PREDEVELOPMENT PLAN REVIEW COMMENTS

Project Number: PPR2020-00001 **Date:** June 1, 2020

Project Address: 452 N. Los Robles

Project Description: Predevelopment Plan Review for a Planned Development that would consist of demolition of all existing buildings on the site and construction of four buildings totaling 255,946 square feet (2.24 FAR) in four to five stories with 227 units of housing and approximately 4,500 square feet of ground floor commercial use above two levels of subterranean parking with 365 spaces.

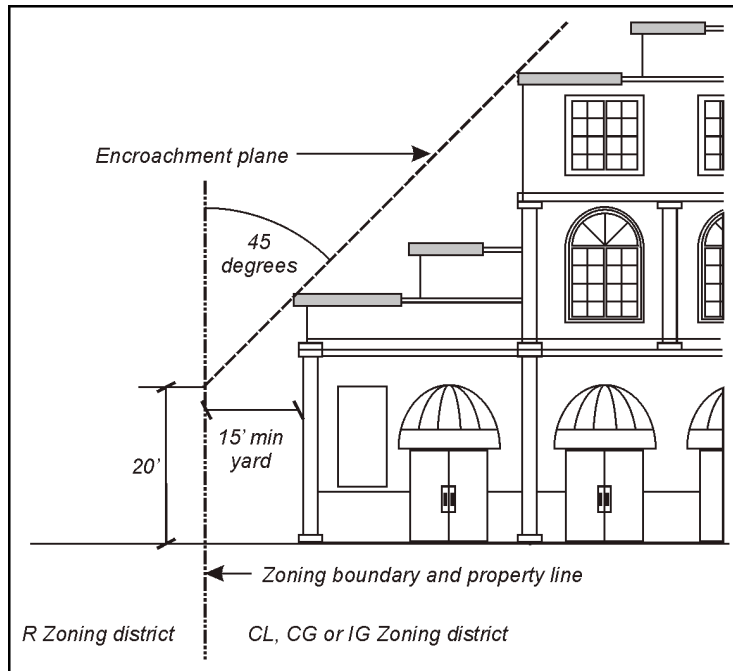
Principal and accessory structures shall not be located within an encroachment plane sloping upward and inward to the site at a 45-degree angle, commencing 20 feet above the existing grade at the property line of the abutting residential zoning district.. See the figure below:

The provided encroachment plane is shown as commencing from 32 feet above the property line. Plans shall be revised to demonstrate compliance with the encroachment plane commencing 20 feet above the existing grade at the property line of the abutting residential zoning district pursuant to Section 17.40.160.D.3. Plans shall indicate the required encroachment plane from each designated side lot line.
